Service Bulletin

SB-10056599-9337

SUBJECT: Service Update for Inventory and Customer Vehicles
Contact between the Fuel Feed Line and the A/C Pipe
Expires with Base warranty

MODELS: 2013 – 2014 Chevrolet Trax with 1.4L Turbo engine

4004602

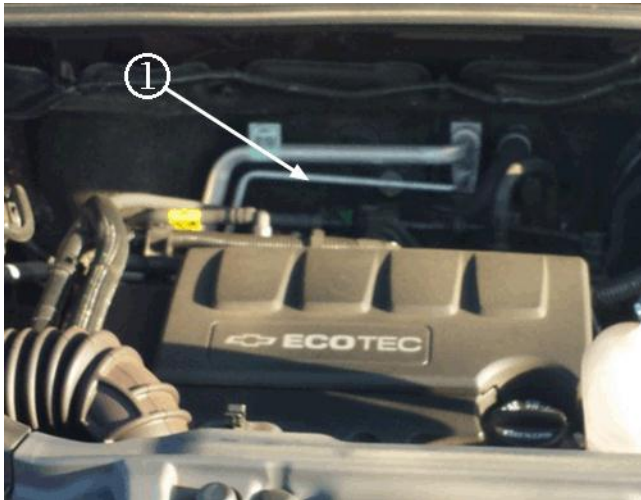
- b. Locate the A/C pipe (1) for inspection.
- c. Inspect the A/C pipe section (1) that is adjacent to the fuel hose (2):
 - i. If the A/C pipe does not show any sign of wear or damage, proceed to step 2.
 - ii. If the air conditioner pipe is worn or damaged, replace the A/C line, refer to *Air Conditioning Evaporator Hose Assembly Replacement Procedure* in SI.

4004608

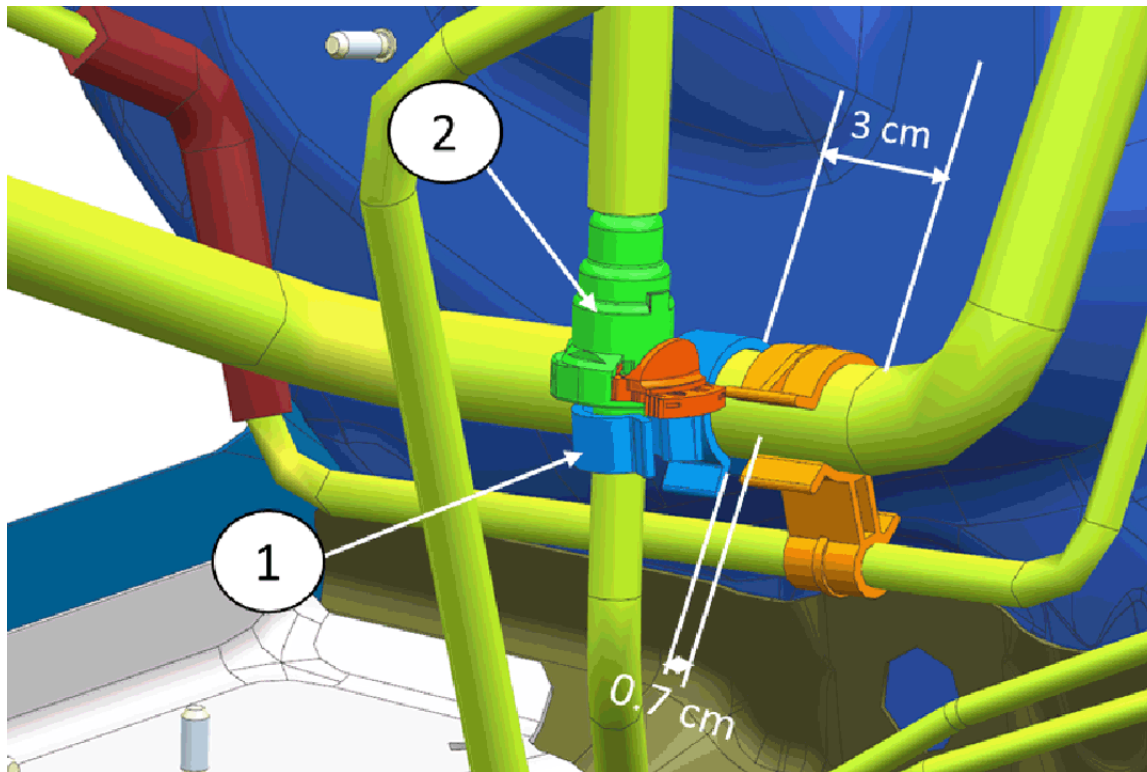
- a. Install the swivel clip (1) underneath fuel hose quick connector (2) as pictured above.
